KMR.CDD.LyQ.1917-1918.01

Re plans of Plot no 58. K-11

With reference to his application dated 12th instant with amended plan for the proposed additional rooms etc: on plot No: 38, K-11 Lyari quarter Mr: Haji Abdullah Saboo is informed that the proposed additions will over-crowd the plot. Permission can only be granted to build to the extent of the present out-buildings to the North. The plans are herewith returned for amendment.

PLAN SHOWING PROPOSED ROOMS

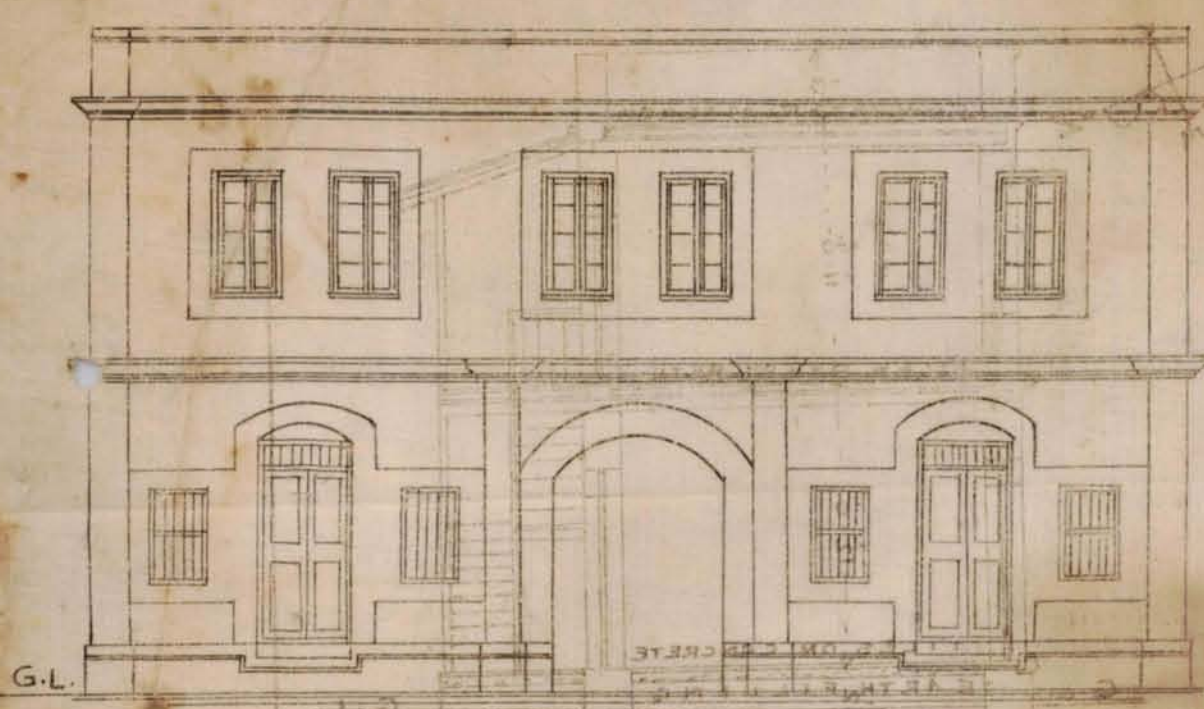
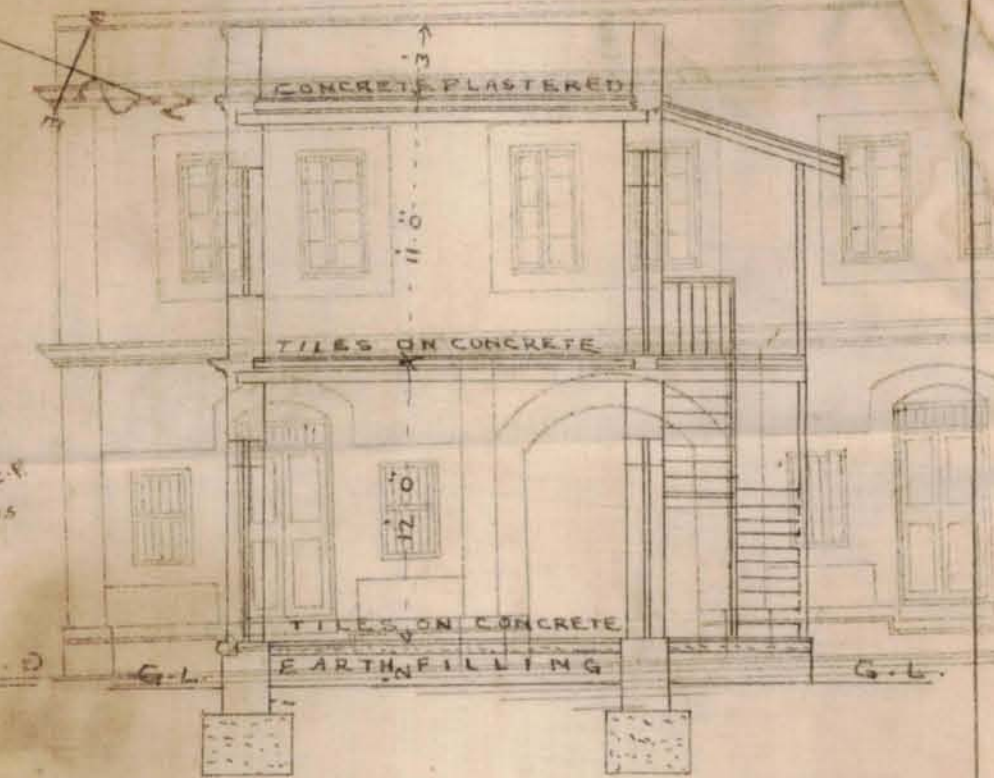
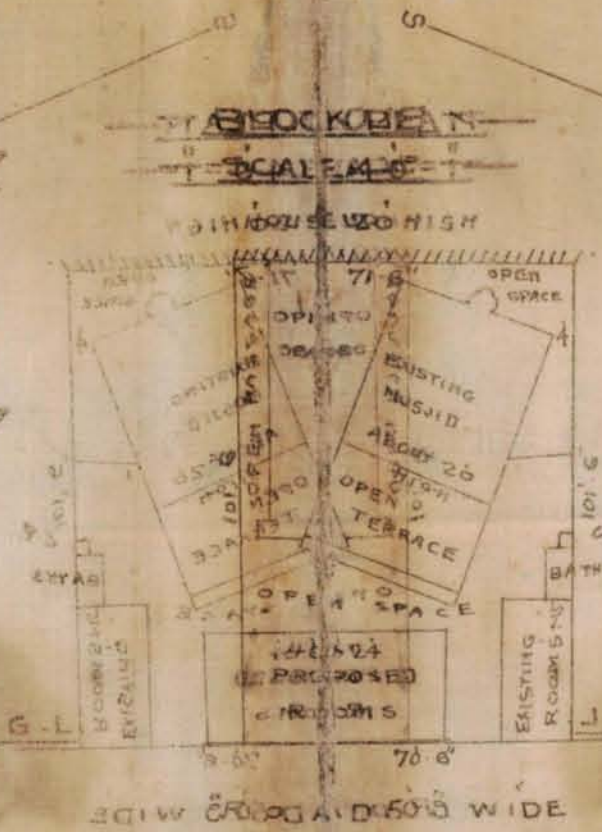
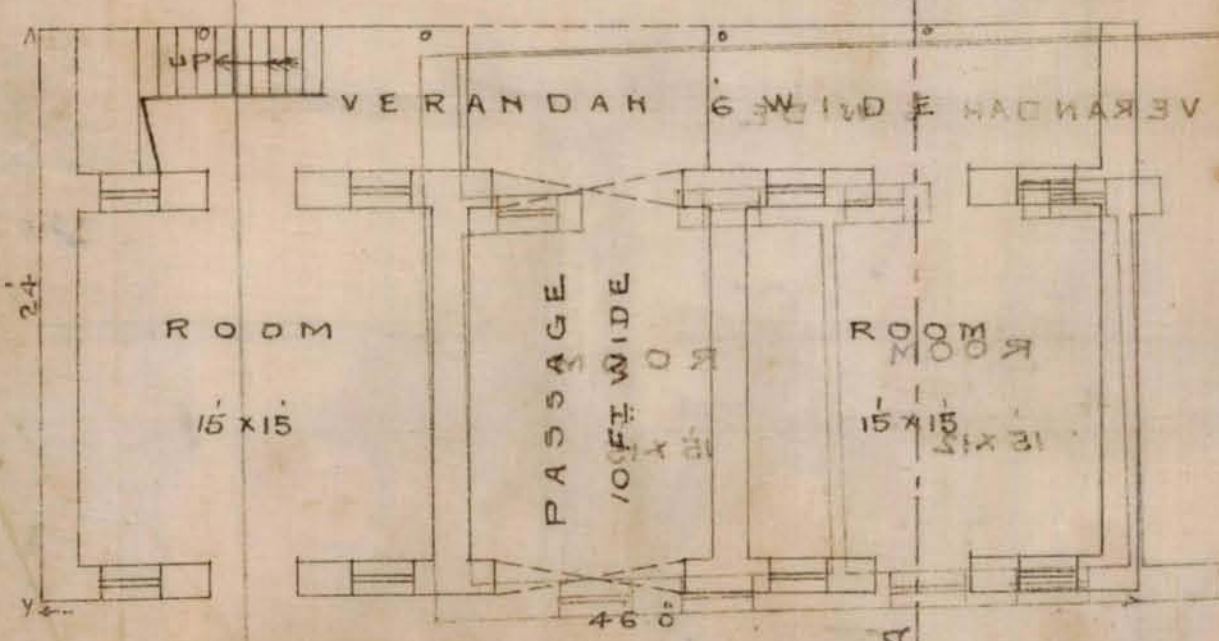
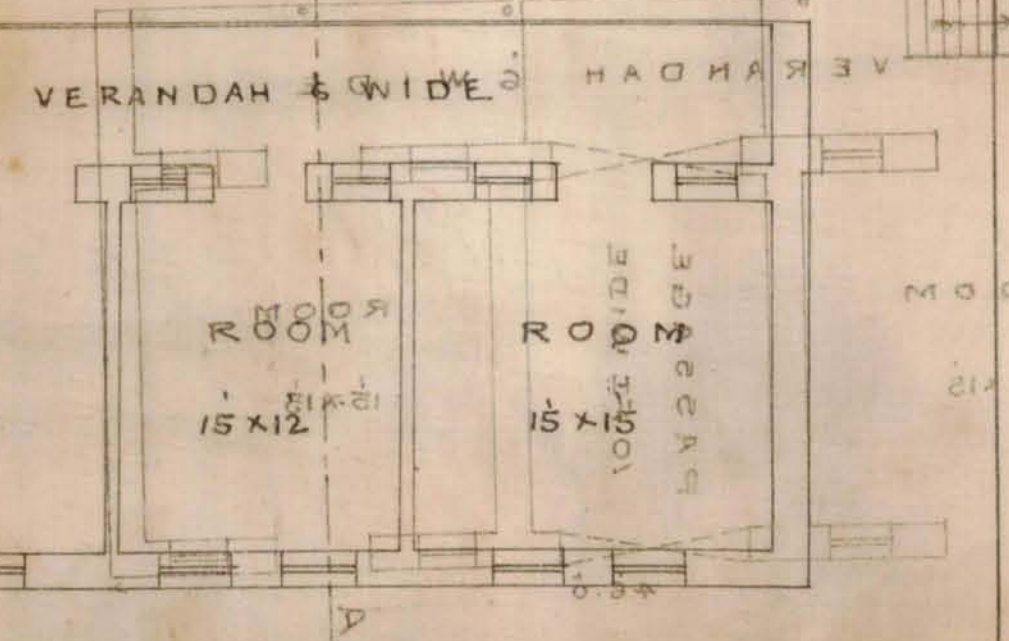
Building Surveyor's Report Sir with reference to this I beg
to report that this Section showing the foundation
of some 7 rooms with 1st floor is not given.
2/ Room adjacent urinals is an insanitary

I beg to attach herewith the approved Plan &
notice served on the owner. The proposed addition
will make the plot overcrowded therefore should not
be allowed. The requirements of the notice have not yet
complied with. S.M. Hassan

The proposed bed will overcrowd the plot. Permission
can only be granted to build to the extent of the present
outbuildings to the north.

With reference to his building under construction on plot No. 38.K-11 Lyari Quarter Mr. Haji Abdulah Sabu is informed it is observed that he is deviating from the approved plan as regards doors and windows and the partition walls on 1st floor. He is therefore requested to make the necessary changes on the plan at Undersigned's office.
